2.0 DESCRIPTION OF PROPOSED ACTION COMMENTS AND RESPONSES

Description of Proposed Action

November 20, 2009

Figure 2-1: Wetland Disturbance
Minisceongo Park
 Towns of Haverstraw & Ramapo, Rockland County, New York
 Source: Atzl, Scatassa & Zigler, P.C.
 Drawing Date: 1/13/09, rev. 8/18/09
 Scale: 1" = 175'

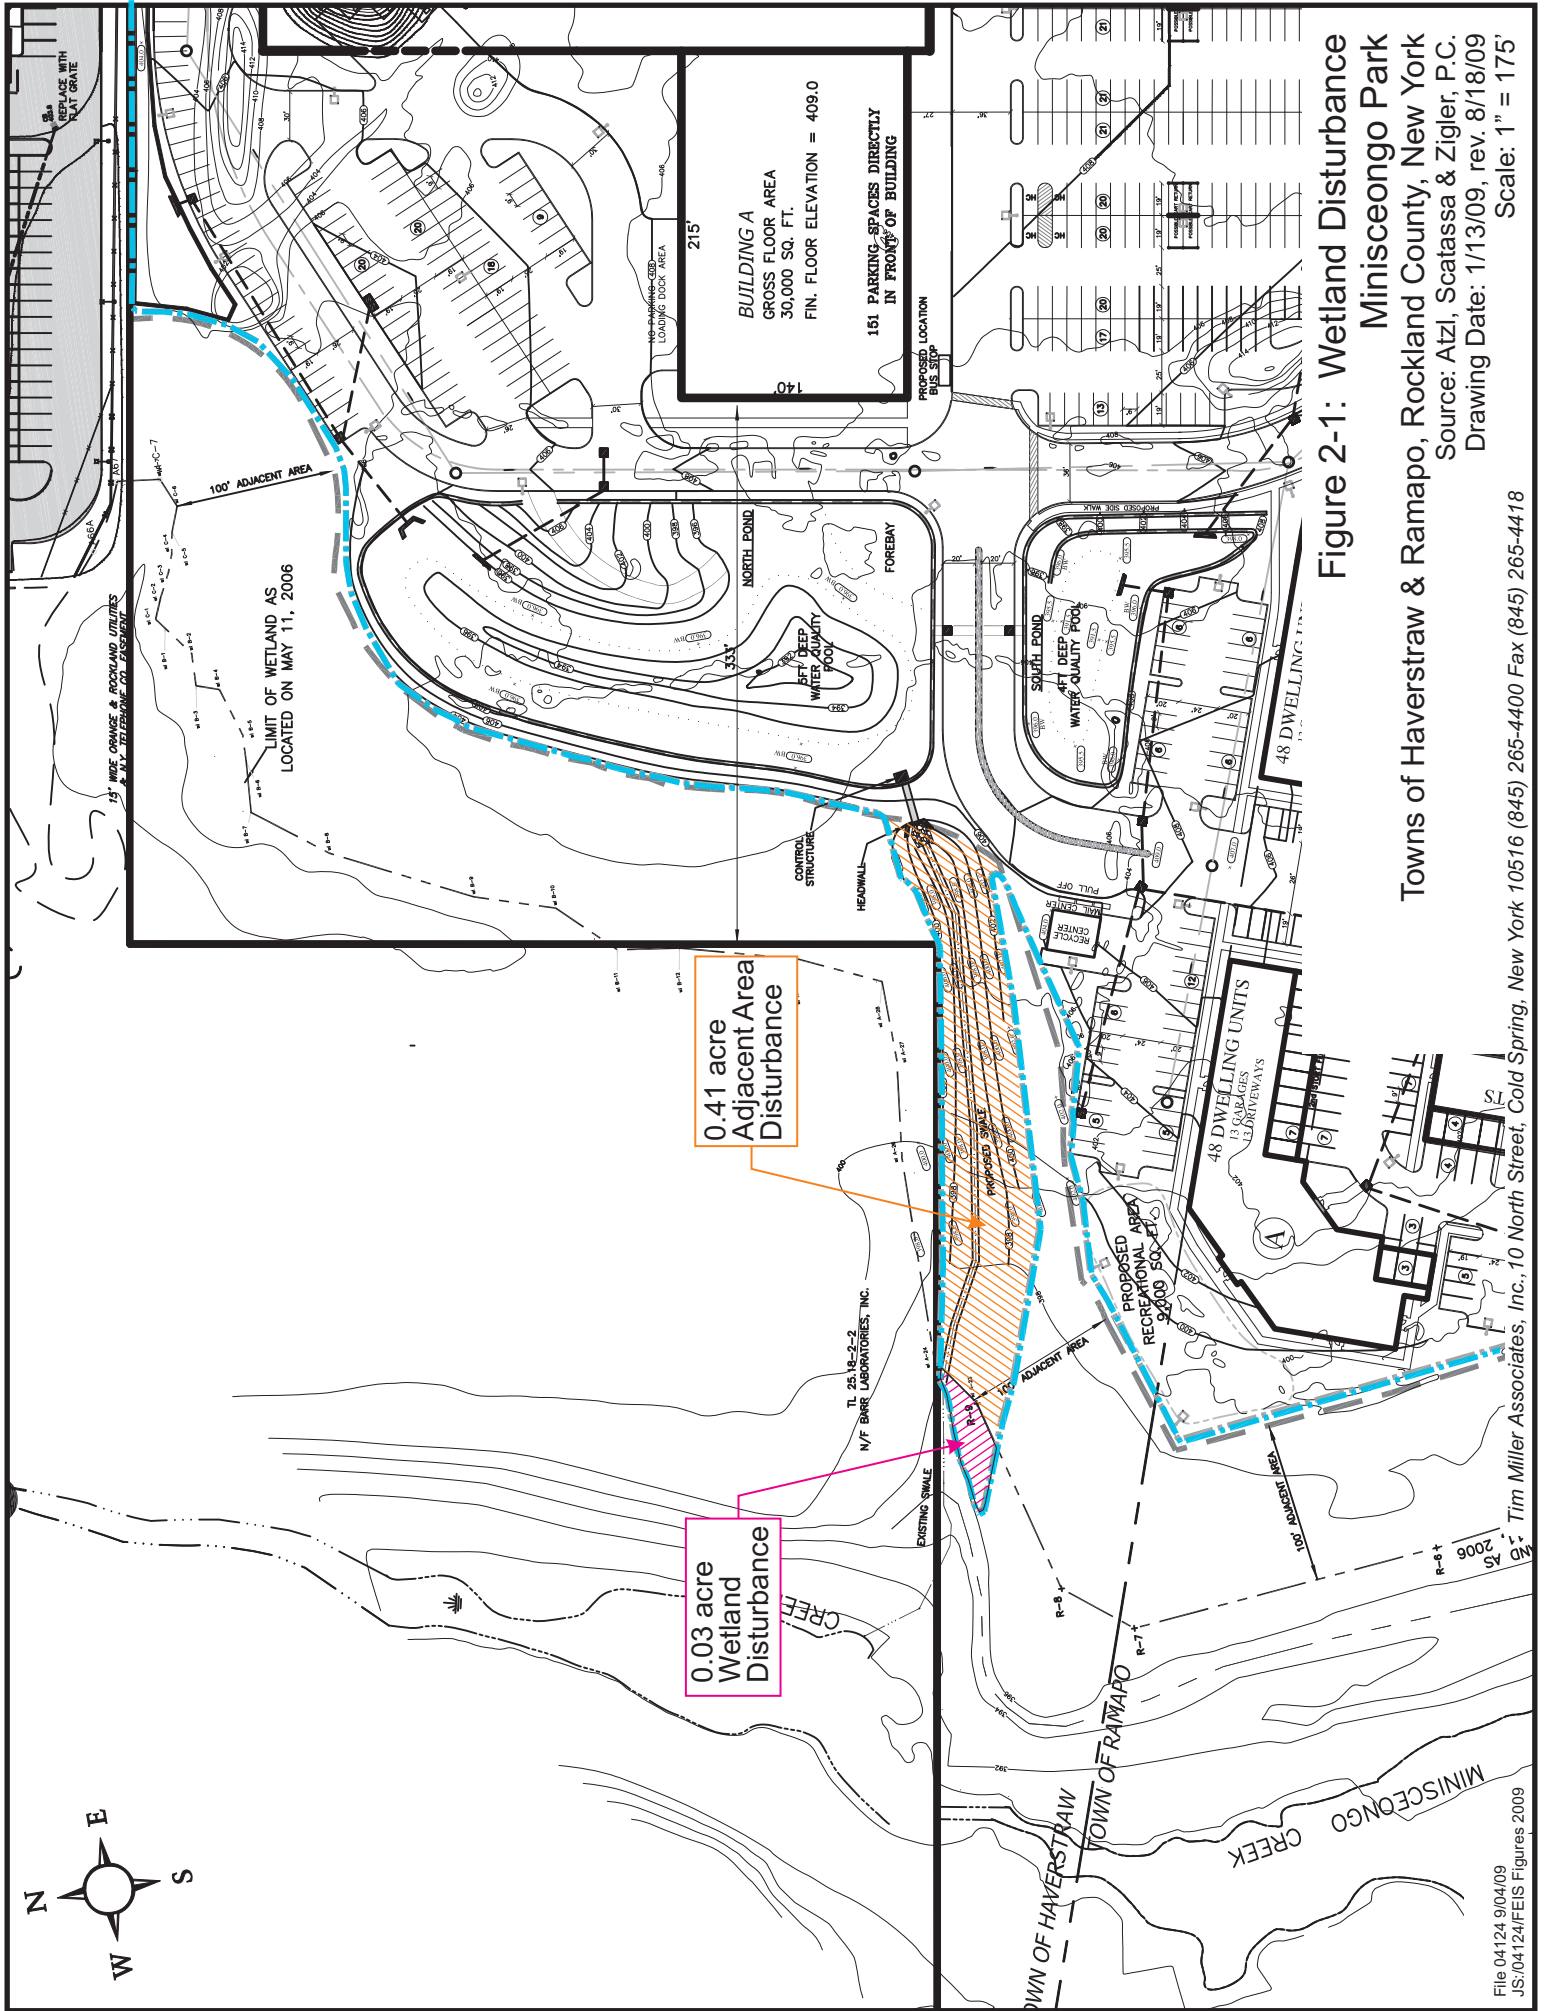
Comment 2-1 (Letter #1 Ralph P. Peragine, P.E., Stephan A. Maffia, P.E., Jay Snyder, and Anthony Agresti, TRC Engineers, Inc., March 4, 2009): The applicable U.S. Army Corps of Engineers ("ACOE") Nationwide Permit number should be identified and whether or not pre-construction notification is required.

***Response 2-1:** With regard to permits and approvals, the Applicant filed a joint permit application on October 16, 2008 - the New York State Department of Environmental Conservation Application is identified as No. 3-3999-00014/00001. The project would disturb no more than 0.03 acres of the ACOE and NYSDEC regulated wetland to install a drainage pipe that would discharge to Minisceongo Creek - see Drawing 3 of 4 of the concept plan set attached to this FSEIS. With regard to ACOE permitting, the activity would qualify under Nationwide Permit 43, Stormwater Management Activities. A pre-construction notification is required.*
